June 23, 2009

**SUBJECT: Cool Car Standards and Test Procedures, Agenda Item 09-6-4**

The Alliance of Automobile Manufacturers (Alliance) and Association of International Automobile Manufacturers (AIAM) together represent every major U.S. automobile manufacturer. This letter provides our comments on the California Air Resources Board (ARB) Cool Car Standards. Automakers support efforts to reduce greenhouse gas (GHG) emissions from their products and factories. On May 19, 2009, automakers joined with President Obama, California, federal agencies, governors, and environmental leaders to announce a commitment to establish a national program that will reduce carbon emissions and increase fuel economy. In line with this commitment, we support the efforts to reduce interior temperature of vehicles and the accompanying emissions associated with air conditioner (AC) use. Over the past year, we have worked closely with your staff to develop regulations that reduce interior vehicle temperature with minimal consumer inconvenience and cost.

## Mobile Phone Interference

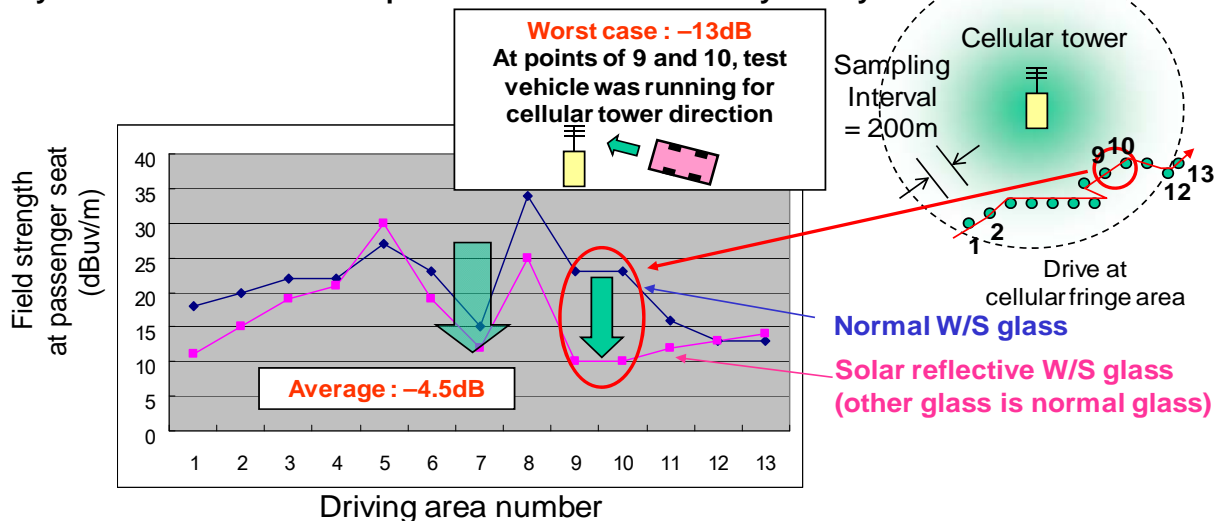
Cell phones are also likely experience weaker signals and more dropped calls as a result of the reflective coatings – this is particularly true as the vehicle travels toward the cell phone tower (i.e., with the reflective windshield toward the cell phone tower). The slide below shows data from testing Toyota conducted to determine cell phone signal strength as a vehicle drives through different cell phone areas.

**Radio wave intensity is decreased by 13dB (worst case), 4,5db(average).  
 Connective area is shrunk by 2/3(average)  
 Connective area is shrunk by 1/3(worst case)**
